GOVERNMENT/INDUSTRY AERONAUTICAL CHARTING FORUM
Instrument Procedures Group
October 25, 2011
HISTORY RECORD

FAA Control # 11-02-297

Subject: Airway "NoPT" Notes on Instrument Approach Procedures

VOR-A
CHESTER(SNC)

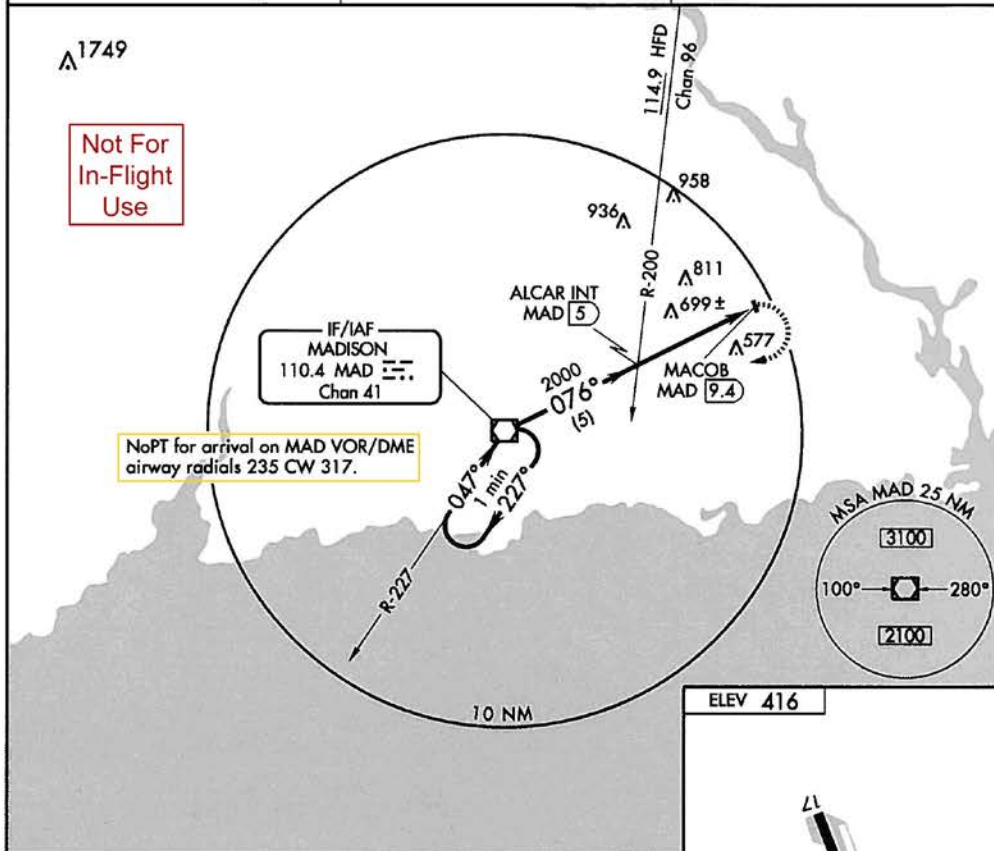
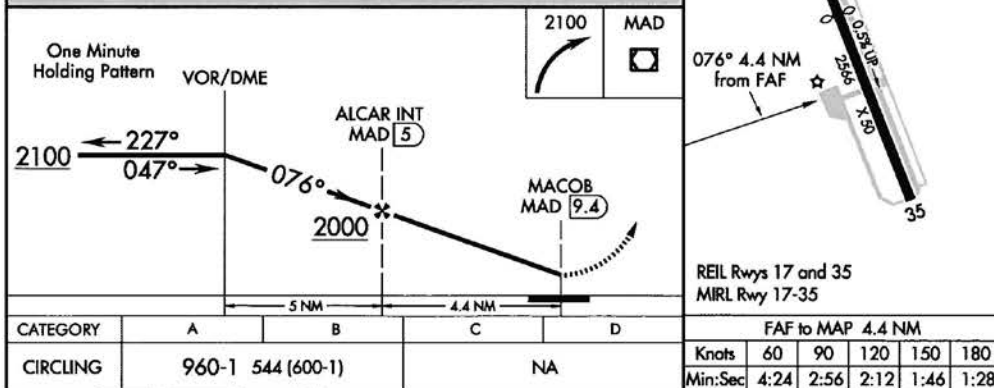
Background/Discussion: Some of the "NoPT" notes on IAP charts are confusing and allow two different interpretations of intent. For example, The note on the Chester, CT (SNC) VOR-A approach states "NoPT for arrival on MAD VOR/DME airway radials 235 CW 317". The note specifies airway radials and Air Traffic expects that aircraft arriving on V-34, V-475, or V-1 from the west comply with the NoPT note and execute a straight in approach. However, the note results in about half of the pilots thinking that it applies to all radials from 235 clockwise to 317. This misinterpretation has been noted in both newly rated and highly experienced pilots.

Recommendations: On the Chester approach note and any other location where ATC wants to apply NoPT only to specific airways, the note must list the specific airway(s) and direction of flight; e.g., "**NoPT for arrival at MAD VOR/DME on V-1 northeast bound, V475 northeast bound, and V-34 southeast bound.**" Additionally enhanced guidance should be placed in the AIM and IPH.

MEETING 13-01: Bruce McGray, AFS-410, reviewed the issue for new participants and provided a recommended solution that should clarify the intent of the note. A copy of Bruce's slides is included here (). The recommended chart note will specify the airway radials; e.g., "***NoPT for arrival on MAD VOR/DME airway radials R-235, R-258 and R-317***". AFS believes the designation of specific airway radials and elimination of the terms "clockwise" (CW) and "counter-clockwise" (CCW), should eliminate human factors concerns

for pilots, controllers, and cartographers alike. Tom Schneider, AFS-420, agreed to include the revised verbiage in the next iteration of FAA Order 8260.19. The issue will be tracked in an "Open - pending publication" status.

CHESTER, CONN
VOR-A

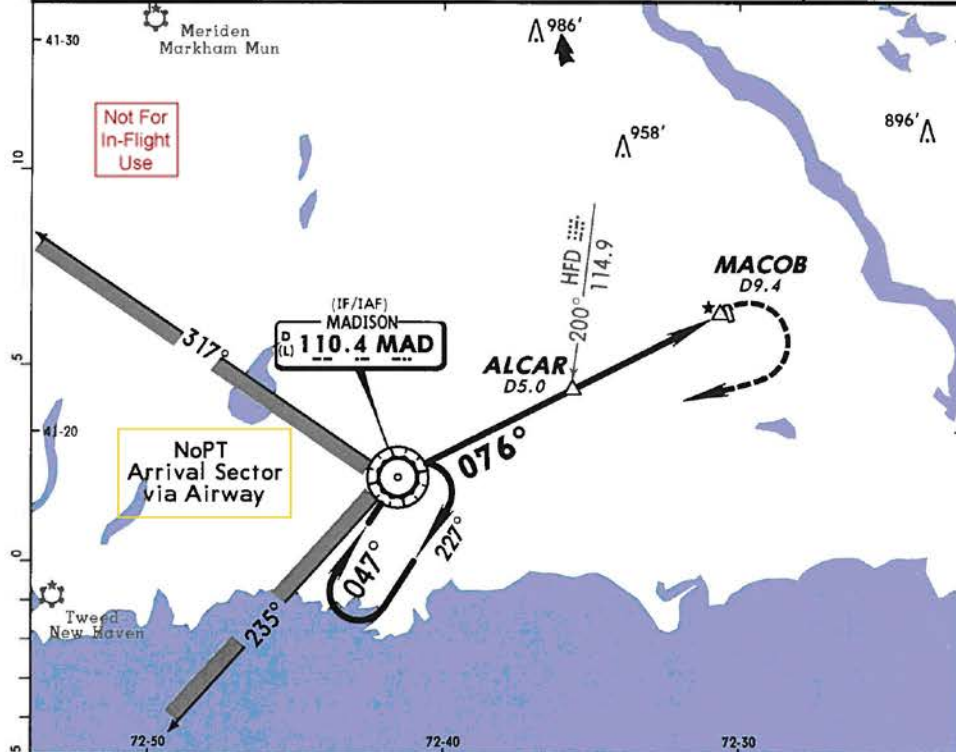
take years to revise all the current charted notes. Paul Eure, AJE-31, stated that with the current proposal to allow ATC to clear aircraft direct to an IAF or IF and for a straight-in approach, the note may be a moot point. Ted Thompson, Jeppesen, stated that back in the early '80s, Jeppesen established one standard for charting these notes. The crux of the discussion is that the current note using the terms "radials" and "clockwise" as well as the Jeppesen depiction tend to support a sector interpretation. If the intent is to be via the airway, then the airway should be specified and not the associated radials, e.g., V1, V475, and V34. Bill Hammett, AFS-420 (ISI) stated that if the airway is specified, then the direction of flight must also be specified to ensure TERPS turn angle requirements are not exceeded; e.g., "V1 northeast bound". Brad noted that some VORs have as many as 8 airways that qualify for NoPT arrivals and specifying a large number of airways and direction of flight could cause some lengthy notes. John Moore, AJV-3B, recommended that the AFS-400 Human Factors Specialist assess the issue. Bruce McGray took the IOU to accomplish this coordination. **ACTION AFS-410.**
